Access Compliance Report

Public Rights-of-Way

Intersection ID: 10477	Main Street: HAMILTON_ST	Cross Street: POLK_ST	Location:	N
ADA ID: E6BE806F10C0	Ramp Type: BlendTrans1	Initial Pass/Fail: Pass	Overall Compliance: No	Severity Score: 10

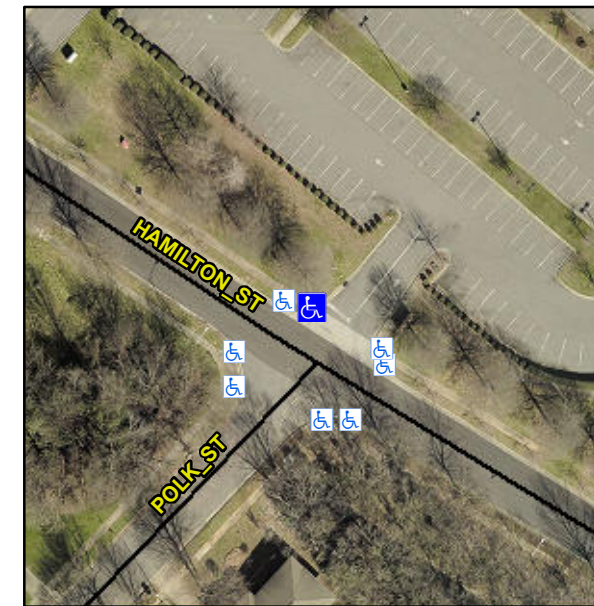
Not Found, R304.2.1, R305.1.4, R305.2, R302.7, R302.7.2

N/A	Ramp inside XWalk1?	N/A	N/A	Ramp inside XWalk2?	N/A
	Road Slope (%)	1.3		Clear Space?	Yes
	Road X Slope (%)	1.8	N/A	Clear Space to XWalk (in)	N/A
Yes	Any Obstructions?	No	Yes	Storm Grate/Utility Hazard?	No
	Obstruction Type			Storm Grate/Utility Type	
		N/A			N/A
			Yes	Surface Condition? (G/P)	Good
			No	Curb Slope (%)	21.9

Remove & Replace Curb Ramp With Two New Directional Ramps or Equivalent.
